CBD BUG submission on Kangaroo Point Bikeway upgrade: stage 1 (Goodwill Bridge to Veloway 1) - South Brisbane

We refer to the preliminary design for Stage 1a and 1c of the Kangaroo Point Bikeway upgrade project released by Brisbane City Council on 22 November 2017.

Figure 3

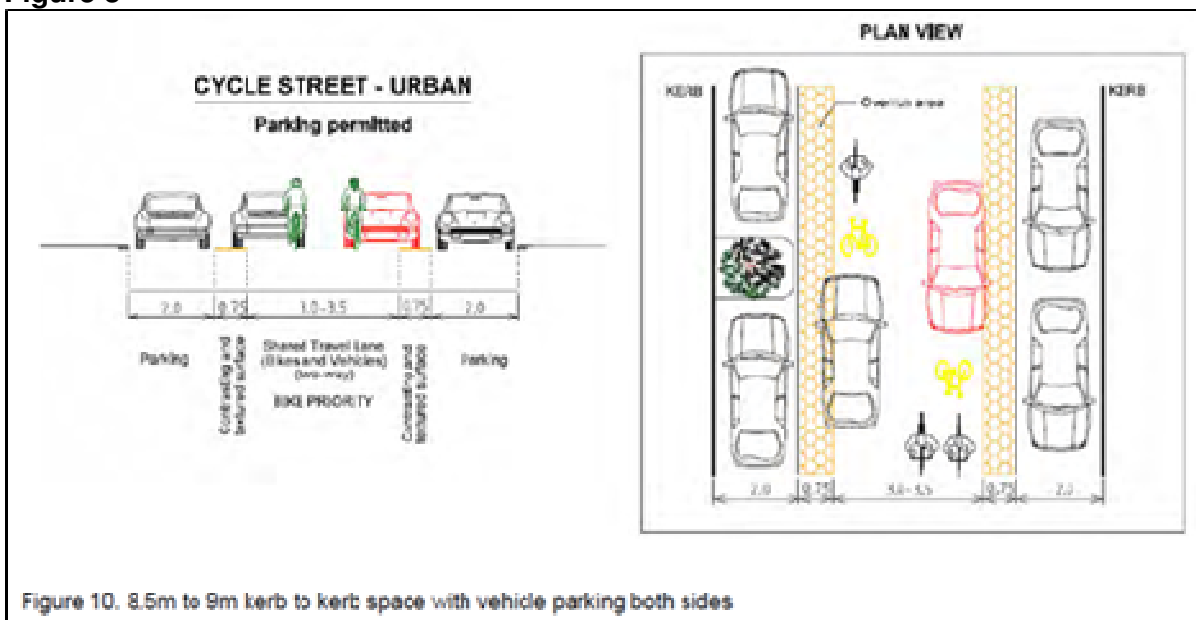
These designs are now supported by the Queensland Department of Transport and Main Roads as per Figure 3 below.

This design should be supported by changing the speed limit from 50km/h to 30km/h. This will provide a disincentive for rat runners, and reduce the risk they pose to people walking and cycling. Changing the speed limit will result in an only an extra 20 seconds travel time for legitimate motorists over the approximate 400 metres spanning from the northern termination of the Veloway 1 Bikeway to the intersection of Dock Street and Vulture Street. This marginal extra travel time is inconsequential compared to the health and potential life costs of someone injured or killed as a result of a crash with a motorist.
